ADDENDUM NO. 2

May 6, 2022

NEW ADMINISTRATION CENTER, ALTERNATE EDUCATION AND RESOURCE CENTER AND RELATED WORK PROJECT
Crown Point, IN 46307

ADDENDUM TWO

SHEET
AR AD-111

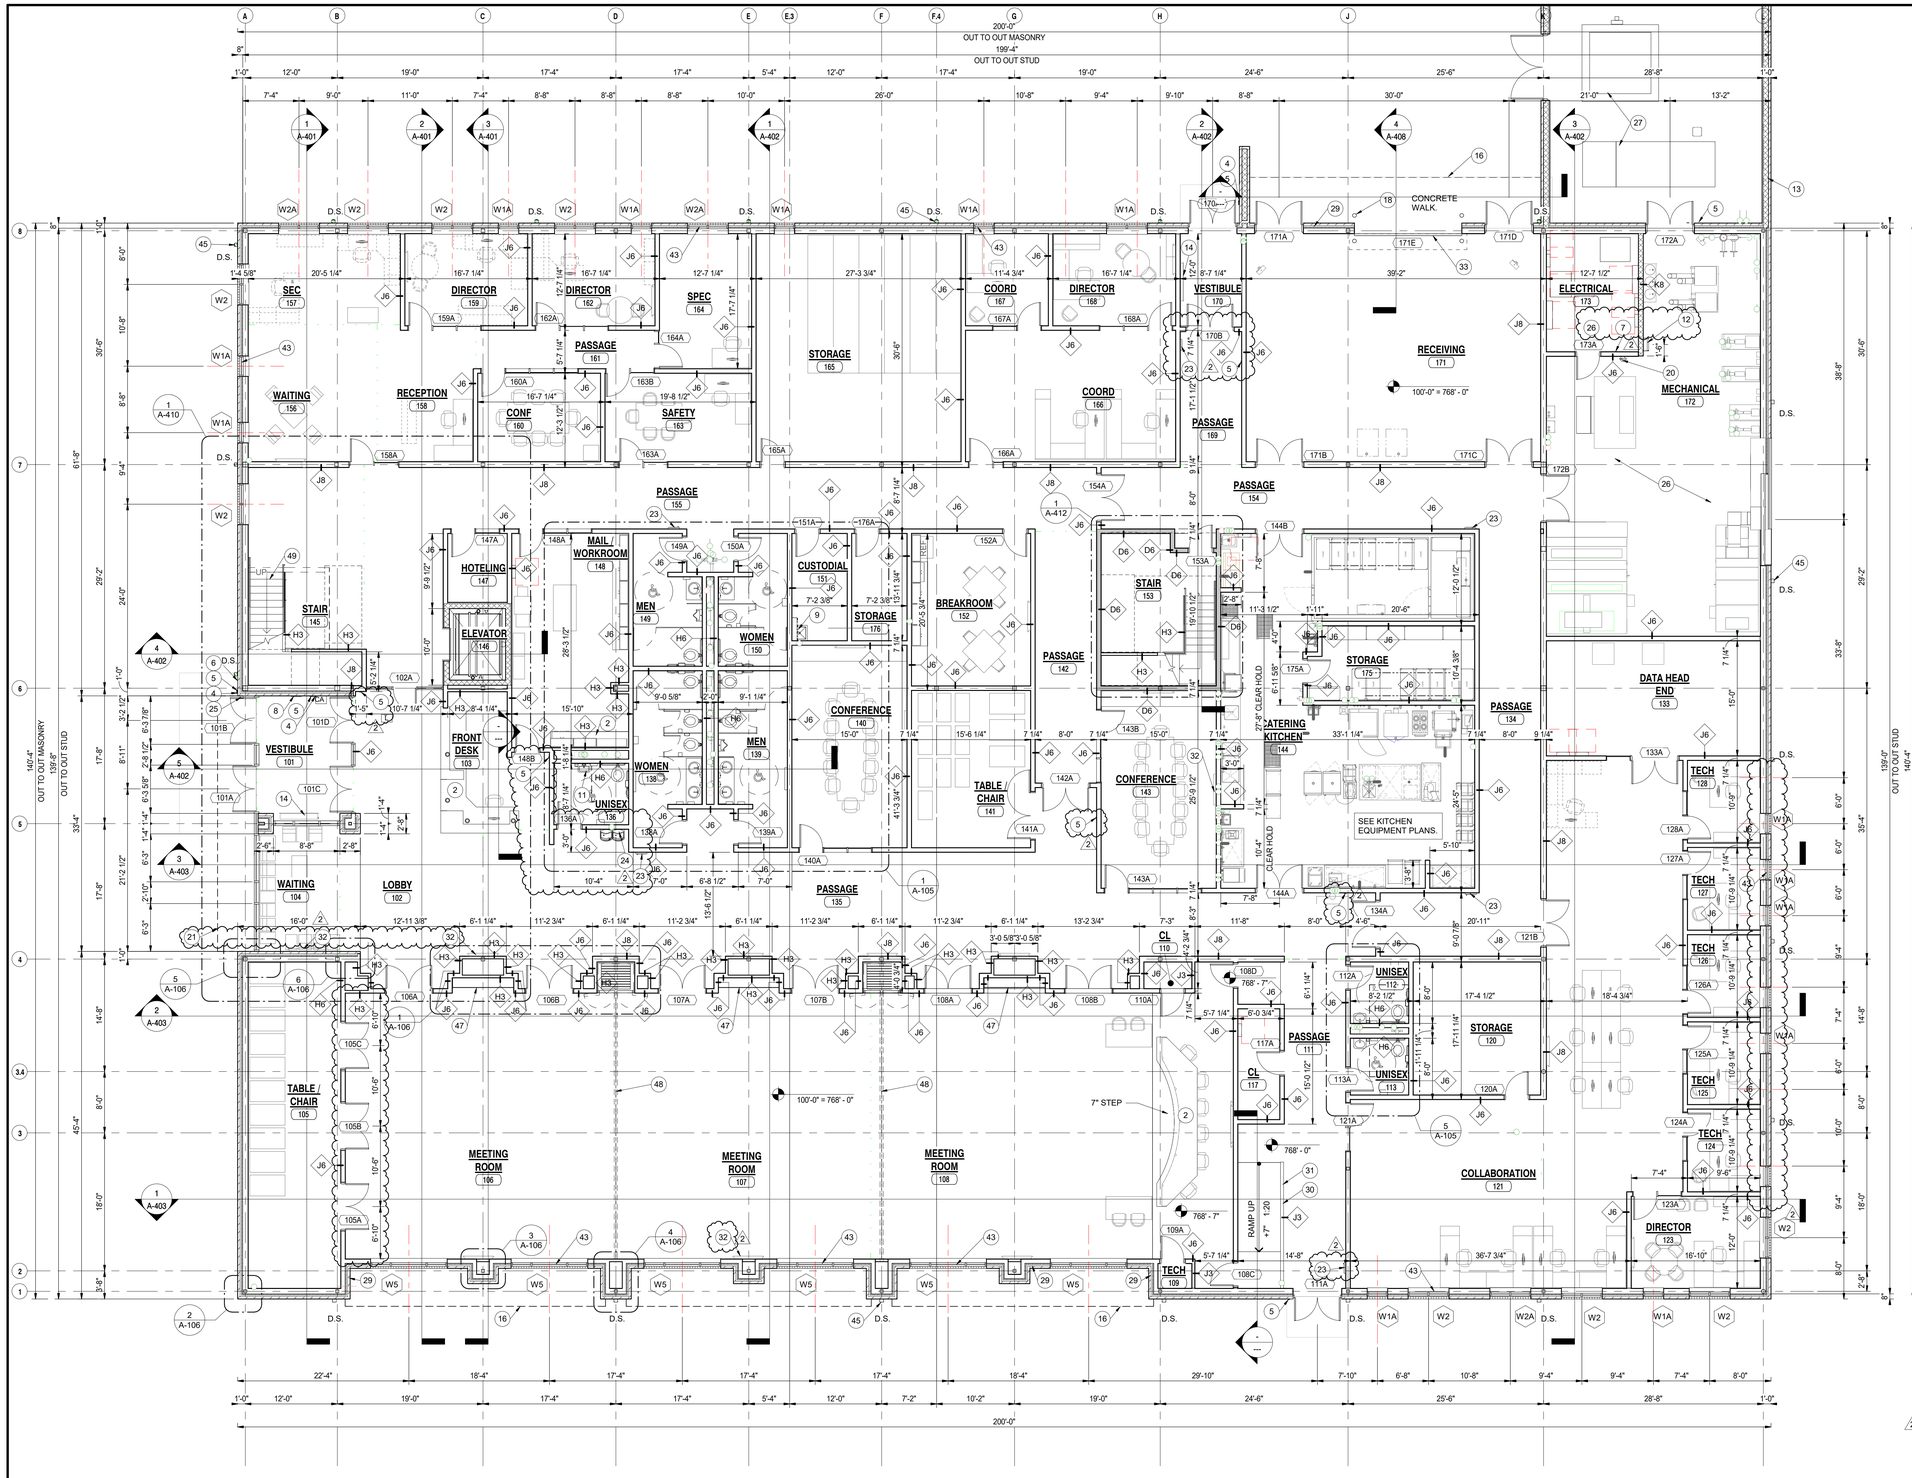
1. Demolition Plan Note clarification on the plan.
2. Clarification – "NIC" indicated on the architectural demo drawing refers to there being no architectural demolition, but MAY be minor mechanical, electrical, or tech demo. Refer to other disciplines demolition sheets for further information.

SHEET A-411

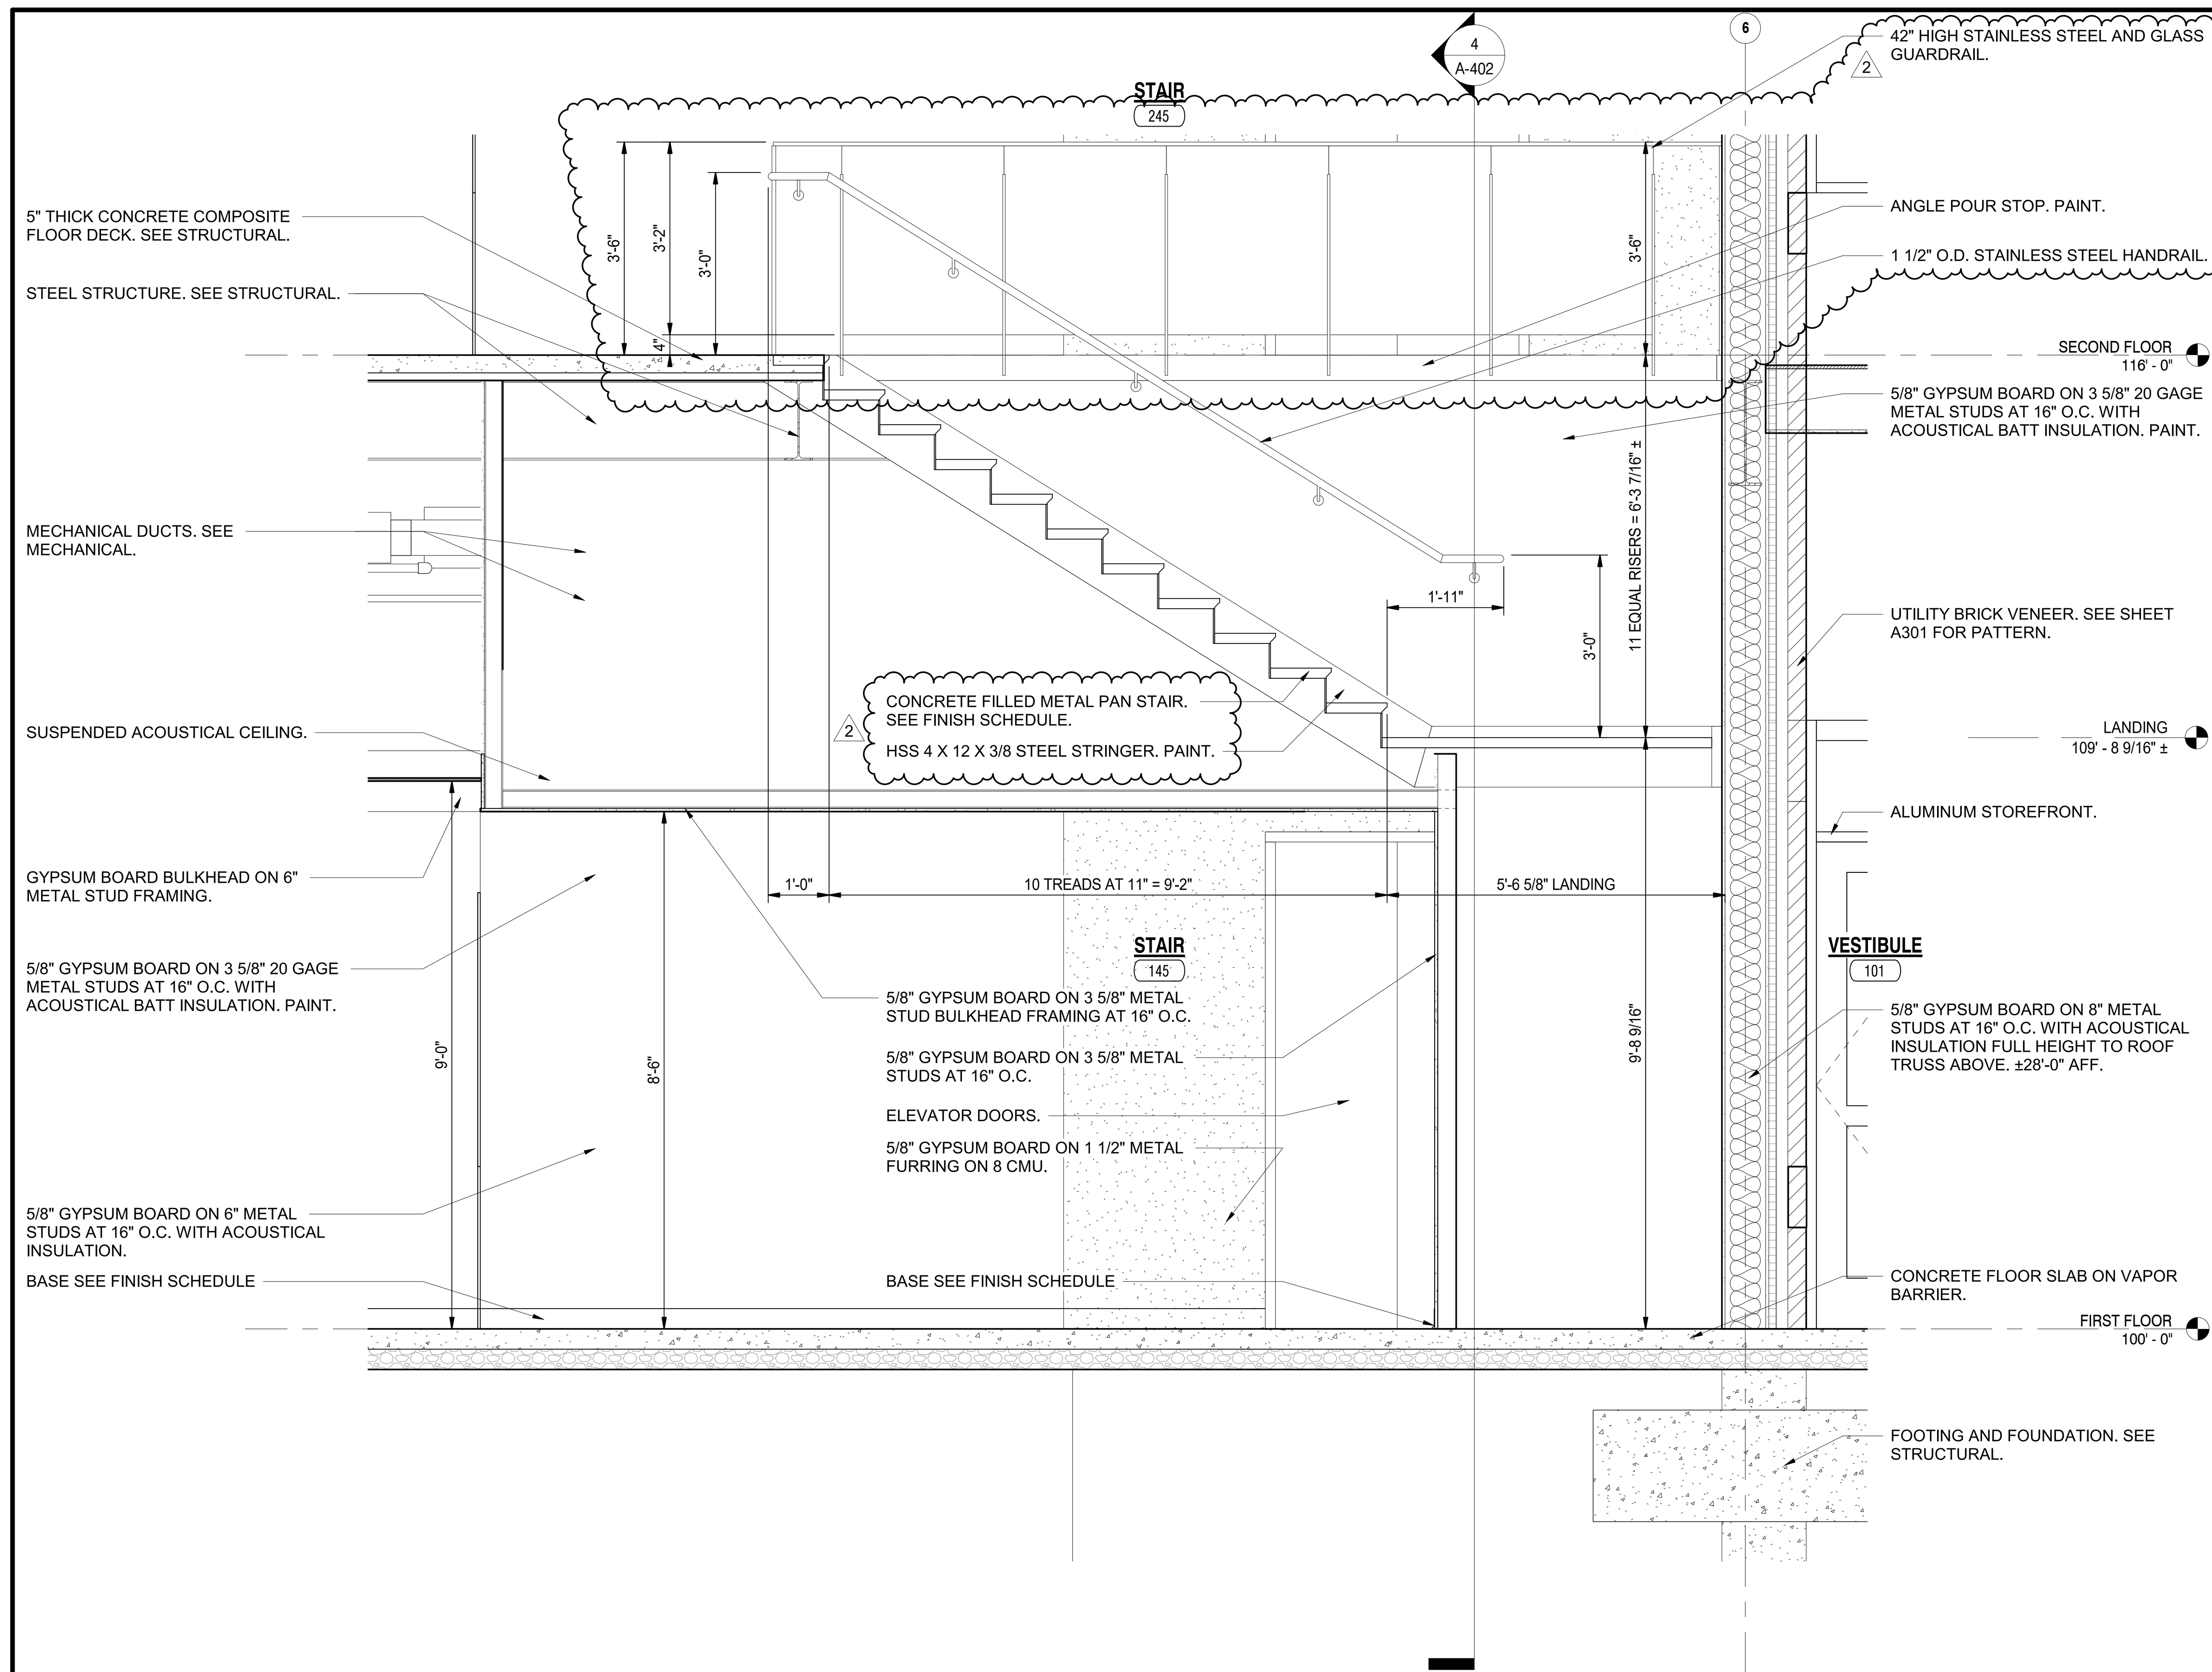
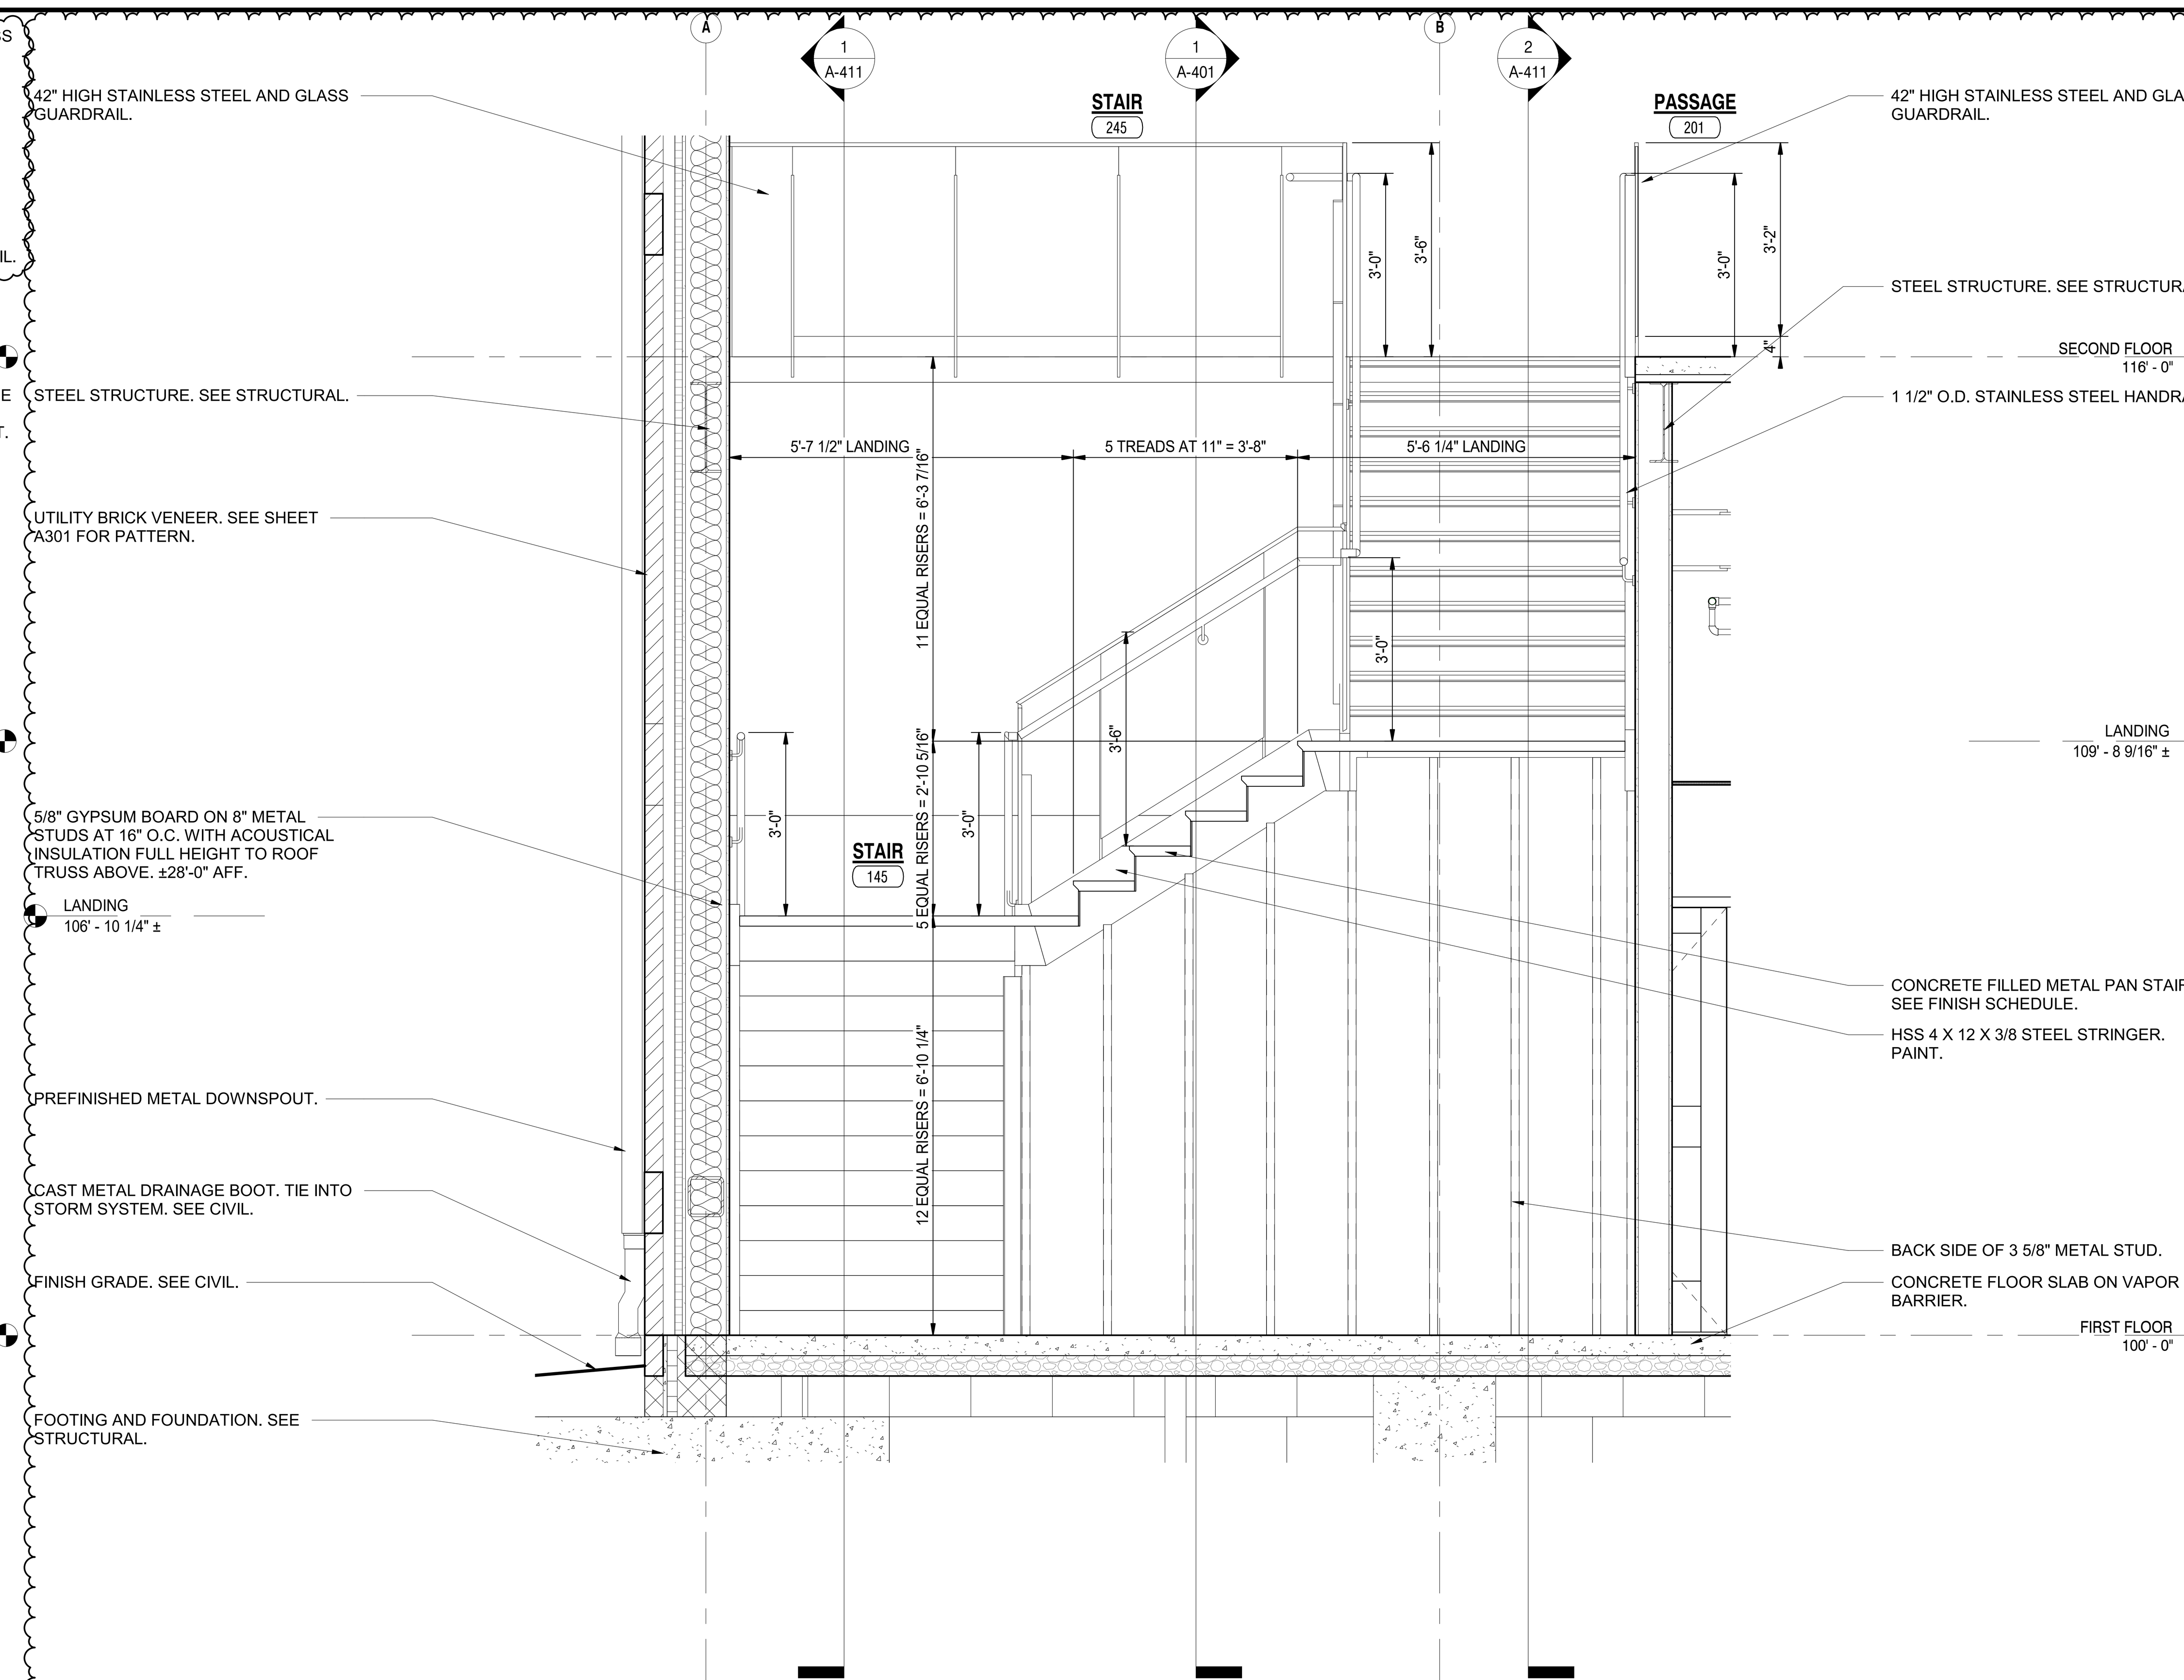
A. Refer to revised, full-size drawing, included in this Addendum, for the following revisions:
   1. Miscellaneous drawing and note revisions.
   2. Change railing at Stair 145/245 to "Stainless steel and glass guardrail and
